## DECISION OF THE HEARINGS OFFICER

**CONDITIONAL USE / CLASS 3 SITE PLAN REVIEW / CLASS 2 ADJUSTMENT  
CASE NO.: CU-SPR-ADJ18-08**

**SUMMARY:** An application to convert part of an existing building to a motor vehicle sales use and reconfigure part of an existing vehicle use area for parking and vehicle display.

**LOCATION:** 3700 Portland Road NE

PROPOSED SITE PLAN

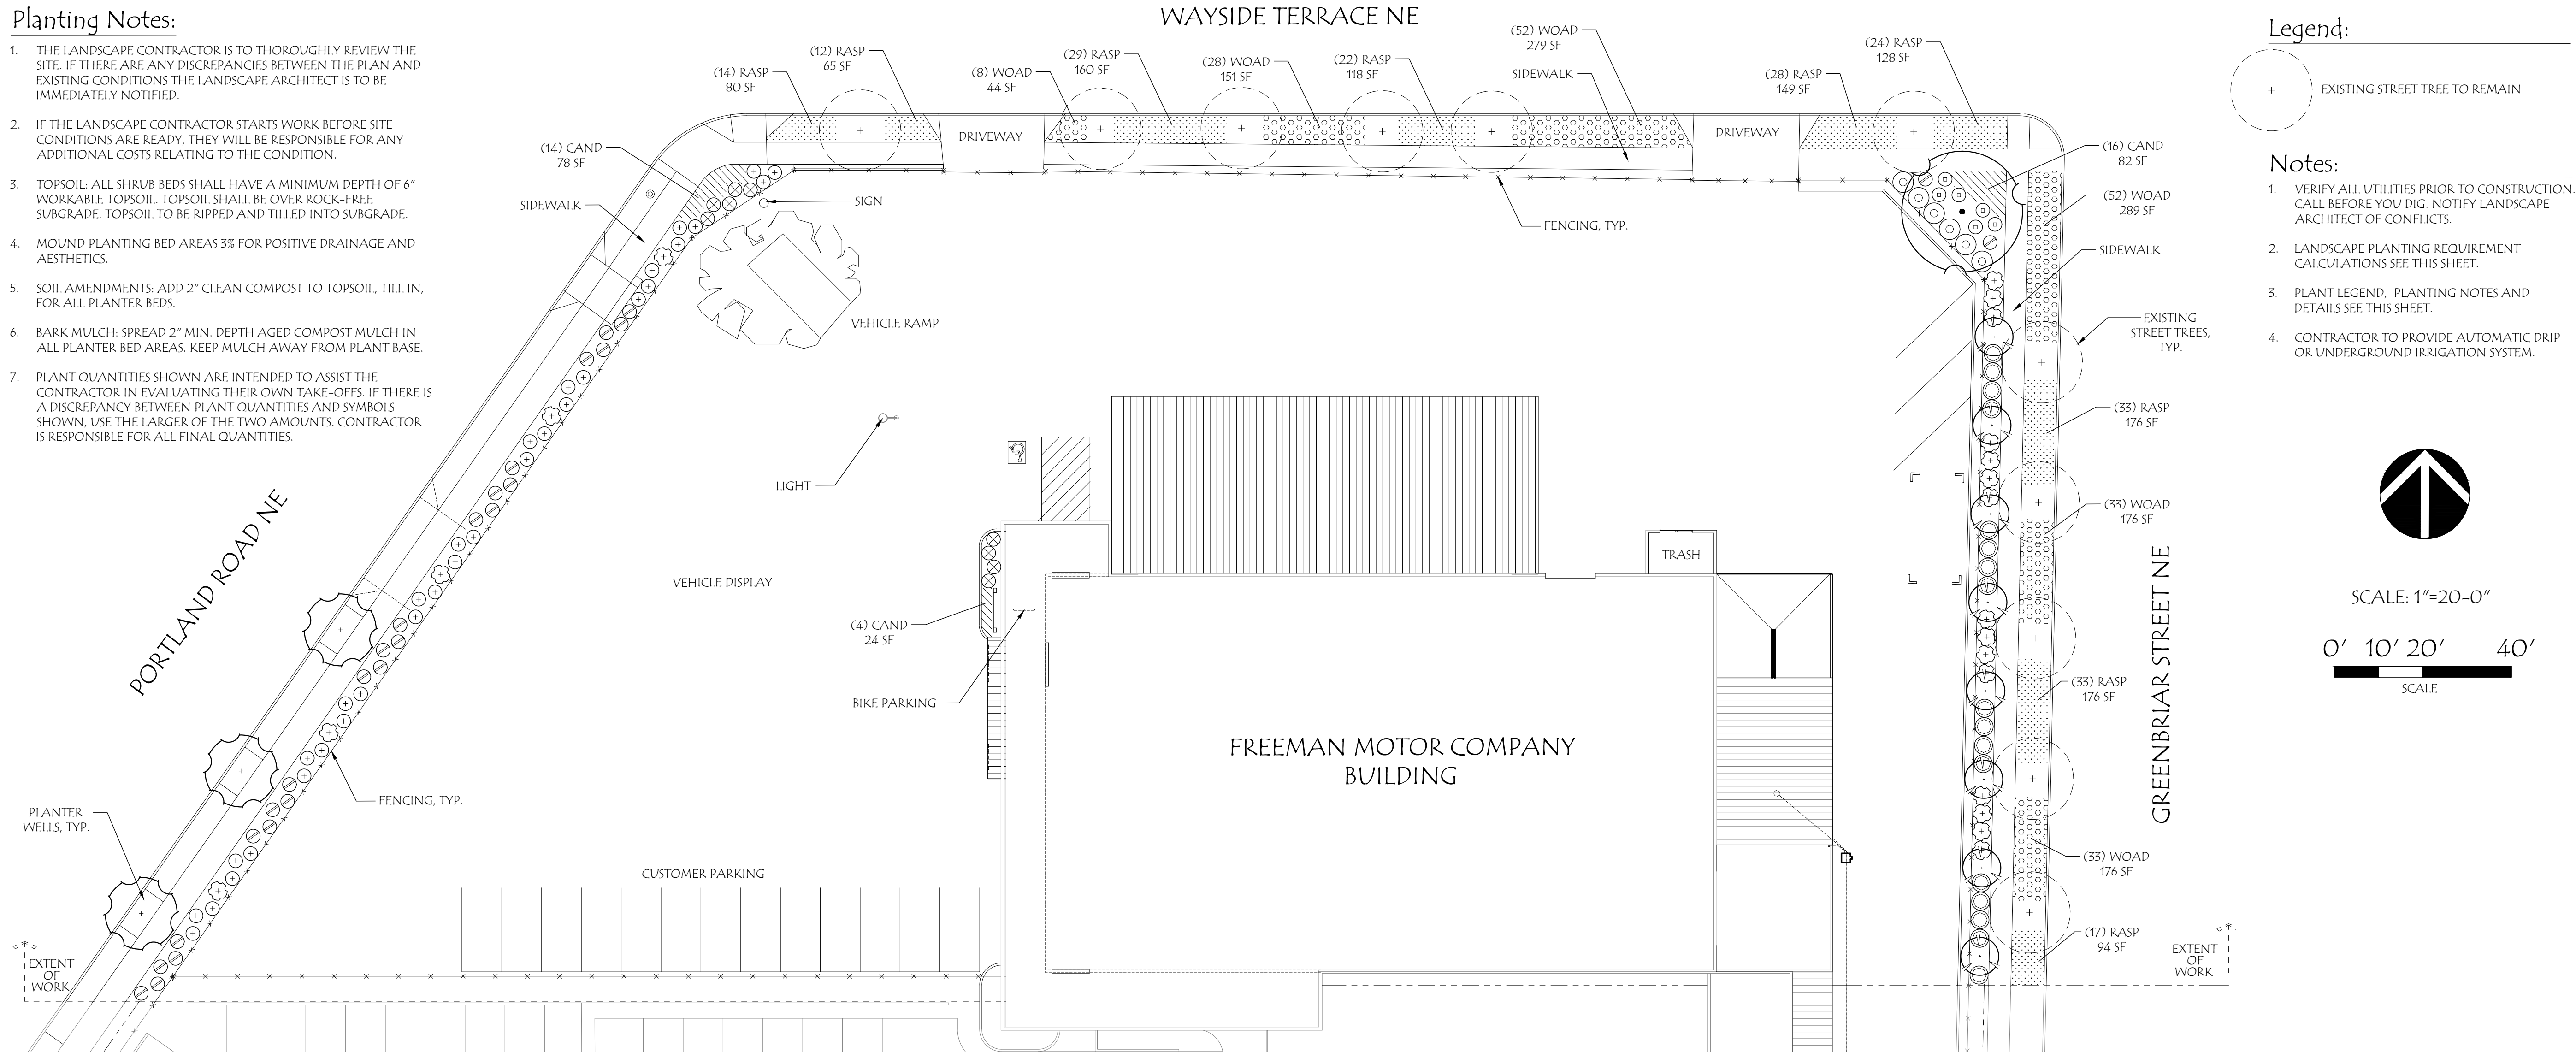
**Condition 1:** The proposed development shall be in substantial conformance with the approved site plan included as Attachment C of the staff report, as modified by the conditions of approval.

The proposed site plan does not indicate details of the solid waste receptacle area. But as conditioned above, this standard will be met.

The Hearings Officer finds that the proposed site plan does not indicate details of the solid waste receptacle area. But as conditioned below, this standard will be met.

**Condition 5: Prior to building permit issuance, the applicant shall provide plans to the City demonstrating that the proposed solid waste service area complies with the standards of SRC 800.055.**

## PLANTING PLAN

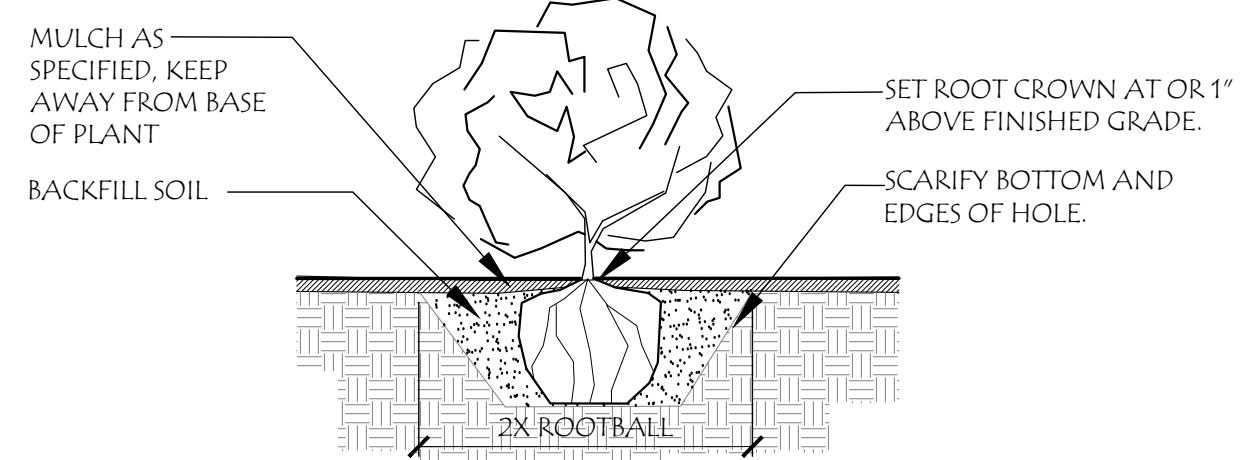
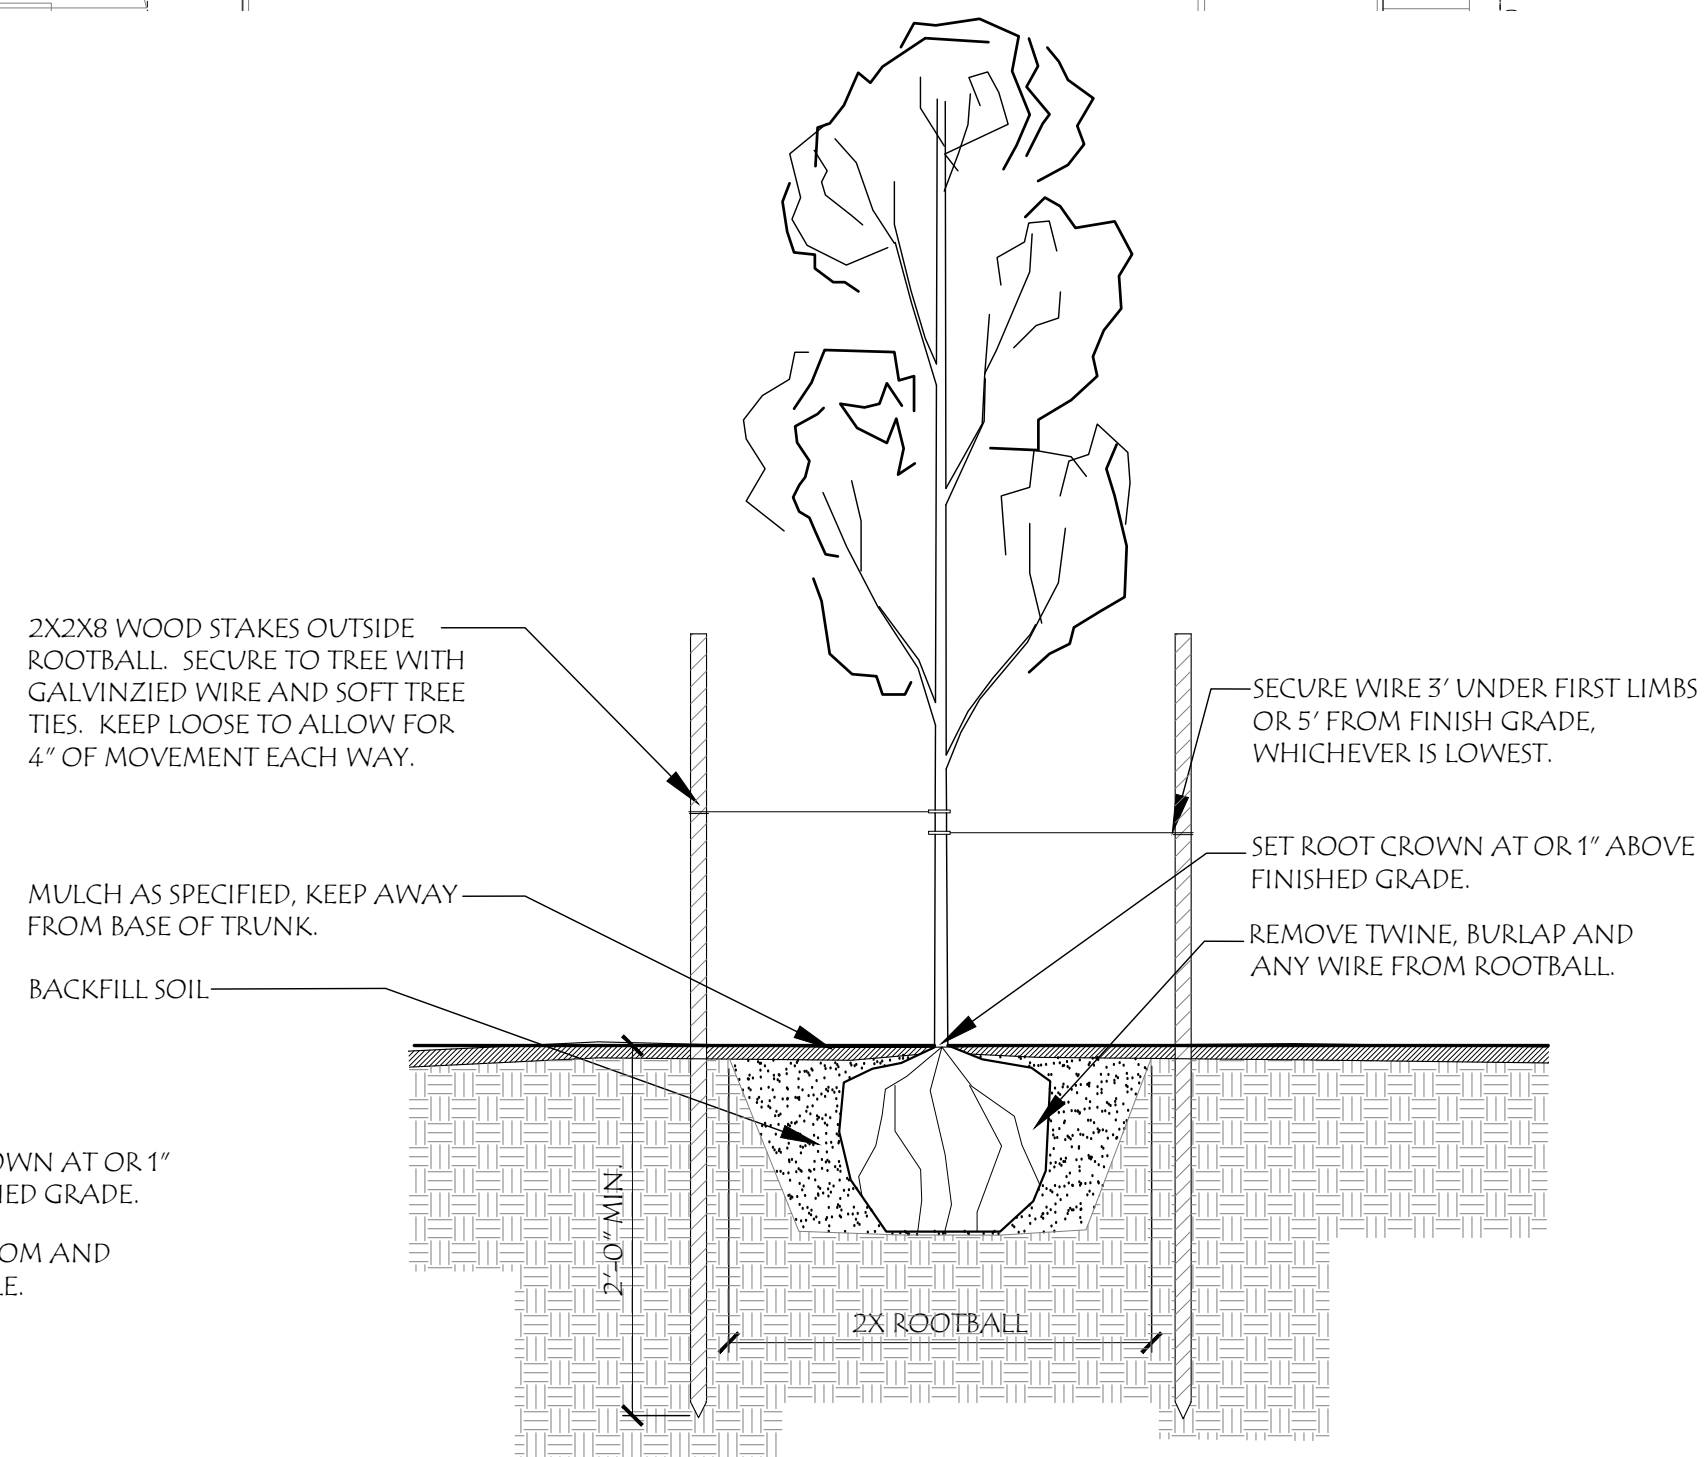
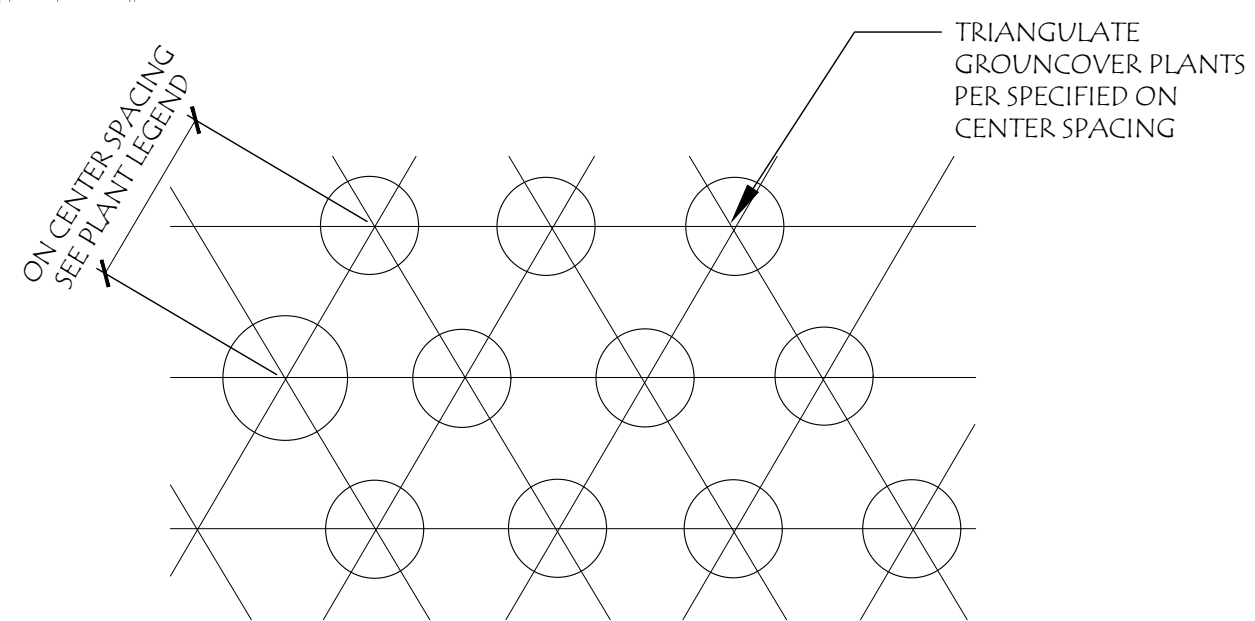
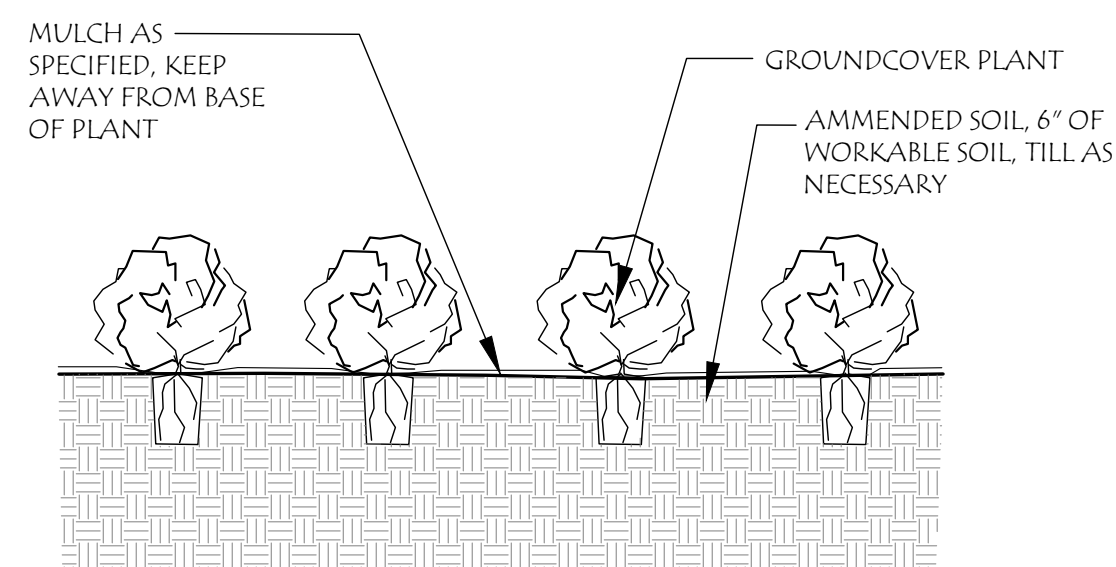
**Condition 2:** The location and width of the proposed landscaping areas shall be in substantial conformance with the landscape plan included as Attachment D of the staff report.

**Condition 3:** All proposed landscape areas, including those in the public right-of-way, shall be planted with a minimum of 1 plant unit per 20 square feet of landscape area and shall be irrigated. A minimum of 40 percent of the required number of plant

As proposed, the landscaping area for the development site would increase by 2.3 percent to 8,057 square feet inside the property lines, requiring a minimum of 403 plant units; the landscaped area would increase by 9.3 percent to 2,135 square feet within the project area, and 5,922 square feet of existing landscaped areas would remain within the remainder of the development site. Of the 403 minimum plant units required, at least 40 percent, or 161 of the required plant units, shall be a combination of mature trees, shade trees, evergreen/conifer trees, or ornamental trees. The proposed landscape area within the right-of-way would provide an additional 2,791 square feet, and the conditions of approval would require planting those areas with at least 140 plant units, including 56 tree plant units.

Although not a condition of approval, the Hearings Officer notes the City's development related concern that the applicant should consult with the Public Works Urban Forester regarding allowable street trees in the public right-of-way and any additional trees that may be required on the landscape plan to meet the landscaping requirements of Condition 3.
